ADDENDUM 2

WHALEYVILLE COMMUNITY CENTER

Whaleyville Community Center Suffolk VA-Project # 1202-10

Questions and Answers

**WHALEYVILLE
COMMUNITY CENTER**
ROBERTSON ST., SUFFOLK, VIRGINIA
SKA-2
EXPANSION JOINTS

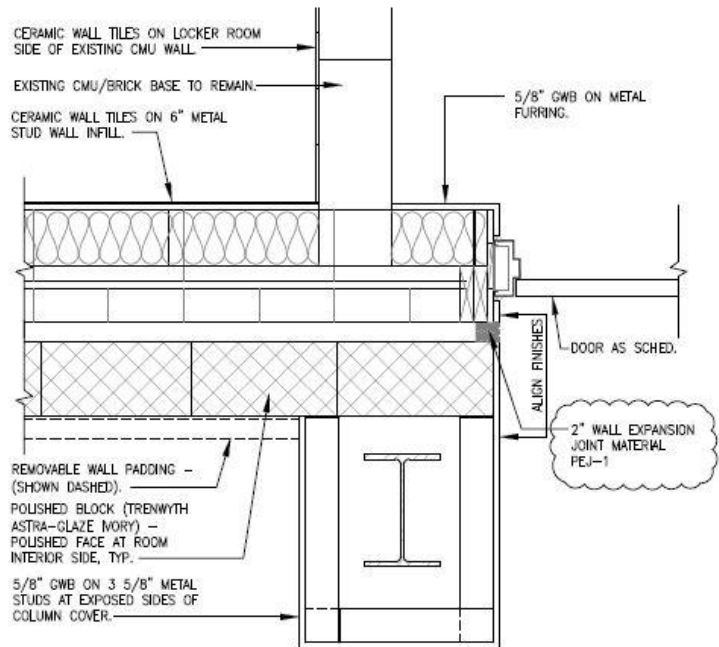
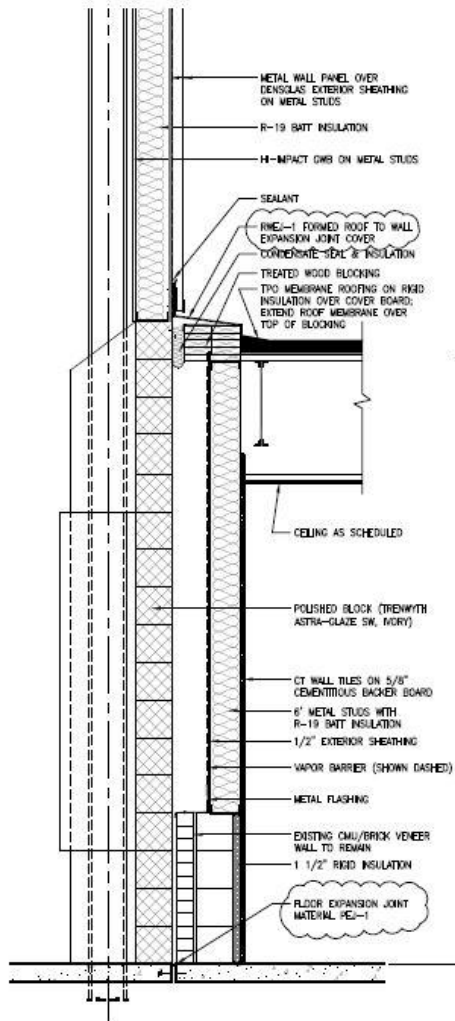
15. The wall construction above the masonry is inconsistent. Section 2/A302 indicates sheathing over the cold-formed metal framing whereas several other sections do not. And in some cases it appears there are steel channels within the framing. With this design, there will be no need for wall girts or opening frames since the specified metal wall panels (exposed fasteners, 36” wide with ribs 12” on-centers) can be installed on the metal stud framing. I suggest the use of added horizontal hat channels to be placed on the sheathing at intervals as suggested by the metal panel manufacturer. Therefore, all metal stud framing will need to receive the sheathing. I believe this to be the designer’s intent. Is this correct?

Please see these additional specs for expansion joints shown above:

| | SKA-3 |

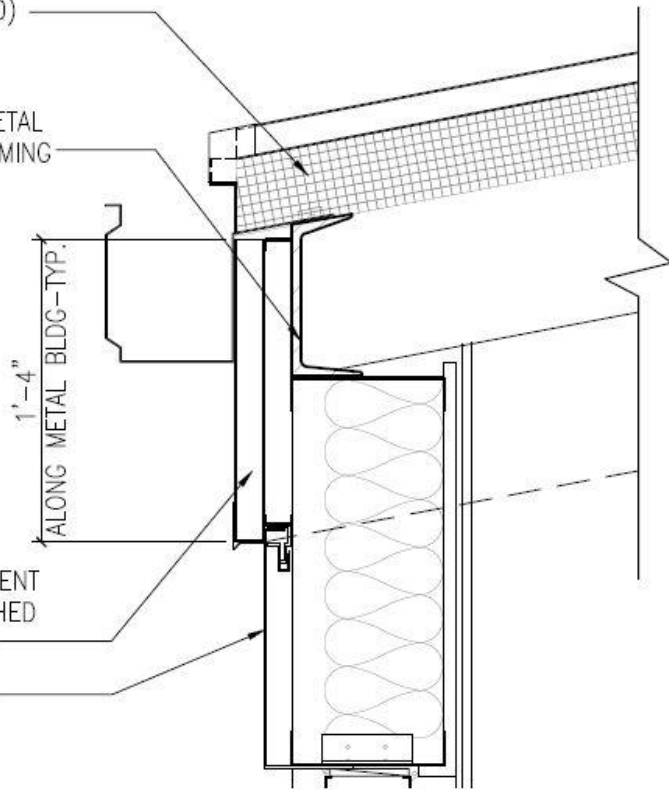
17. And, I'm somewhat confused regarding the accent panels. These panels appear to be drawn the same as the metal wall panel but it also appears that the intent of the designer is to have a flat surfaced panel, trim or fascia. Identification of these accent panels on wall sections vary; some identify them as "Metal Panel Accent Band", some as "Metal Flashing (Match Accent Band)", and the Building Elevations note them as "Metal Panel Trim / Accent Band and/or Fascia to match Colonial Red Metal Roof". I do not believe the intent was to have these metal wall panel material with exposed fasteners, 36" wide with ribs 12" on-centers. Also, there is no indication of how these accent bands attach to the metal wall panel or below the metal wall panel (is this band attached to sheathed metal stud framing?). Please advise.

Please see attached SKA-3.

STANDING SEAM ACCENT
METAL PANEL ATTACHED
TO METAL FURRING
